# Westgate Industrial Estate 253 – 267 Aldington Road, Kemps Creek

## BCA Statement of Compliance Reference 2021/1332 R2.0

Prepared for Icon Oceania Kemps Development Pty Ltd  
9<sup>th</sup> October 2023

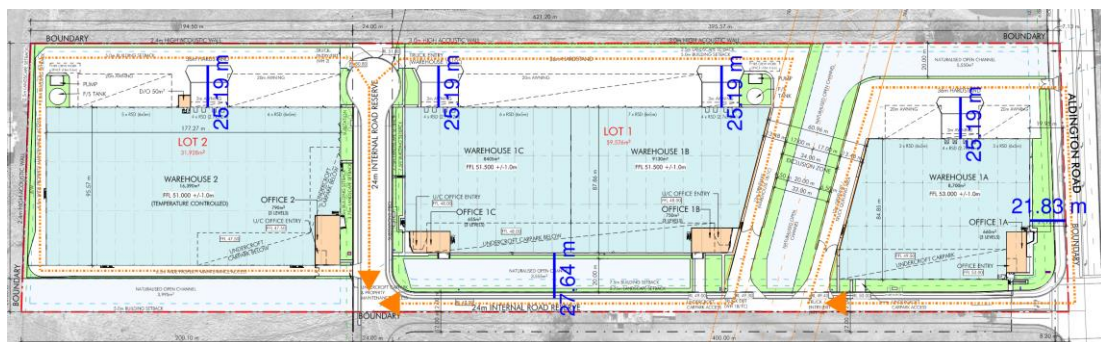
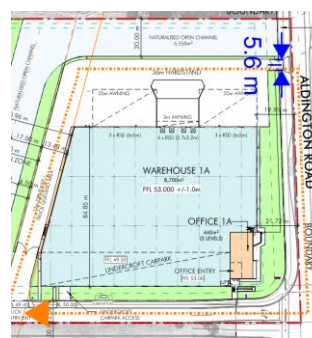
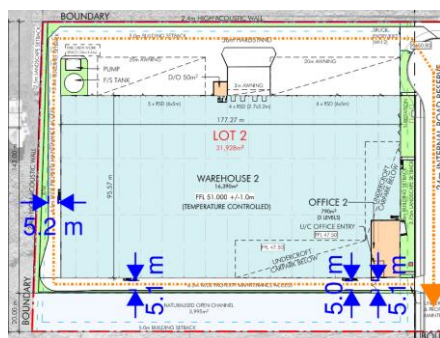
Item	Non-Compliance	DTS Clause	Description	Performance Requirement
3.	<b>Requirements for open spaces and vehicular access</b>	<b>C3D5</b>	<p>The following departures associated with the perimeter vehicle access are to be addressed:</p> <ul style="list-style-type: none"> <li>The vehicular perimeter access road is situated greater than 18m to the following areas:                             <ul style="list-style-type: none"> <li>Up to 25m to the North of each warehouse in isolated instances;</li> <li>Up to 21m to the East of Warehouse 1A (Aldington Road);</li> <li>Up to 28m to the South of Warehouse 1b &amp; 1 C;</li> </ul> </li> <li>Contains portions of the perimeter access road of a clear width of less than 6m as per the following:                             <ul style="list-style-type: none"> <li>Reduced to 5m along the south and western elevations of warehouse 2 for the length of the elevation in parts due to obstructions.</li> <li>Reduced to 5.6m due to the gates located on the North-Eastern corner of Warehouse 1A.</li> </ul> </li> <li>Security gates are also proposed to cross the vehicular access path where the vehicular access road connects to the public road.</li> </ul>	C1P9

**Obstructions within the perimeter vehicle path – Gates**

**6m perimeter path deviations – Path Exceeds 18m**

**Perimeter Vehicle Path where 6m width is not achieved**

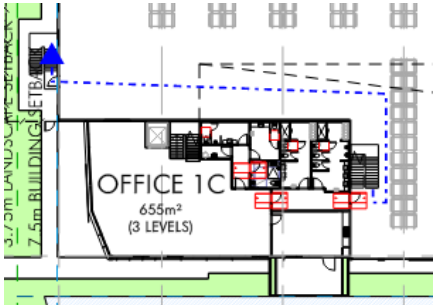
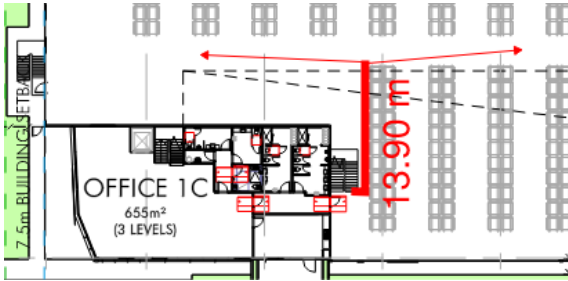
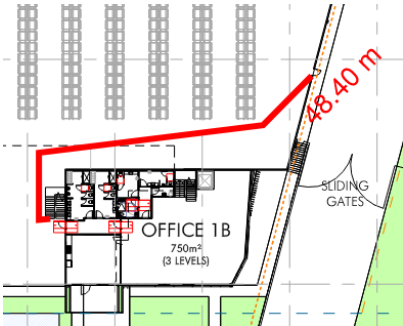
6.	<b>Travel by non-fire-isolated stairways or ramps</b>	<b>D2D14</b>	<p>The following departures are to be addressed through a performance basis:</p> <ul style="list-style-type: none"> <li>• A discontinuous means of travel is applicable for Warehouse 1C where the office non-fire isolated stairs</li> </ul>	D1P4, D1P5 & E2P2

Item	Non-Compliance	DTS Clause	Description	Performance Requirement
			<p>sends occupants to an external stair to reach the level of a road or open space</p>  <ul style="list-style-type: none"> <li>A Point of choice is not directly available at the bottom of the non-fire isolated stair serving office 1C and requires occupants to traverse approximately 14m to where a point of choice is available.</li> </ul>  <ul style="list-style-type: none"> <li>The use of the following non-fire isolated stair to warehouse 1B to the level of the road or open space exceeds the permissible distance where you have a point of choice of 40m of travel (Up to 50m)</li> </ul>
